NASA/TM-2009-215711
NESC-RP-04-02/03-002-E

Possible Deficiencies in Predicting Transonic Aerodynamics on the X-43A

NASA Engineering and Safety Center Consultation Position Paper	Document #: RP-04-02/ 03-002-E	Version: 0.01
	Title: Possible Deficiencies in Predicting Transonic Aerodynamics on the X-43A		Page #: 1 of 13

ITA #: 03-002-E	
Requestor Name: Richard Wood NASA Langley Research Center	Requestor Contact Info: (301)-864-6174 r.m.wood@larc.nasa.gov
Short Title: Possible Deficiencies in Predicting Transonic Aerodynamics on the X-43A	
Description: Monitoring and evaluation of X-43A independent FRR process in its disposition of the issues raised in a dissenting opinion e-mail (officially documented in HyperX RFA 20).	
Date Received: 10-28-03	Date ITA/I Initiated: 11-06-03
NESC Chief Engineer (NCE) Assigned: Michael Gilbert	NCE Contact Info: (757) 864-2839
Lead Assigned: Steven G. Labbe	Lead Contact Info: (281) 483-4656
Date ITA/I Concluded: March 18, 2004

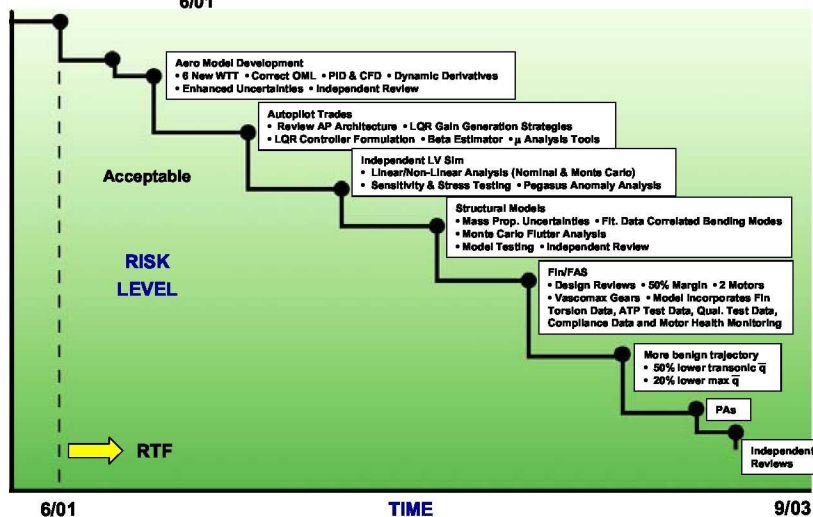
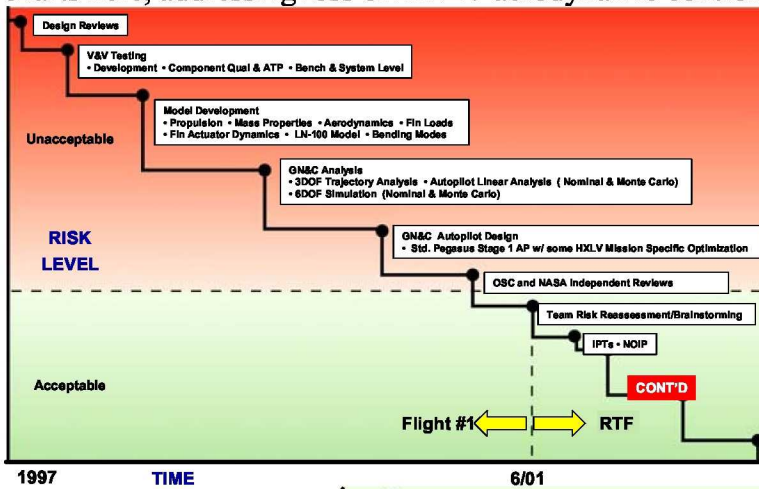
These aerodynamic and flight control RTF activities are highlighted in the risk waterfall charts here, addressing loss of HXLV aerodynamic control.

- 7) Designed the 2nd HXLV for flight control robustness to the possible adverse roll disturbance characteristics by:
- Modifying the trajectory to reduce the dynamic pressure (by ~50%) at transonic conditions to reduce aero loads relative to available control capability
 - Doubling the torque capability of the booster fin actuator to further increase margin
 - Conducting autopilot trades to identify design options of enhancing transonic flight dynamics robustness
 - Developing systematic uncertainty models and conducting appropriate Monte Carlo trajectory simulation analysis
 - Conducting worst case stress cases to define the boundaries of controllability.
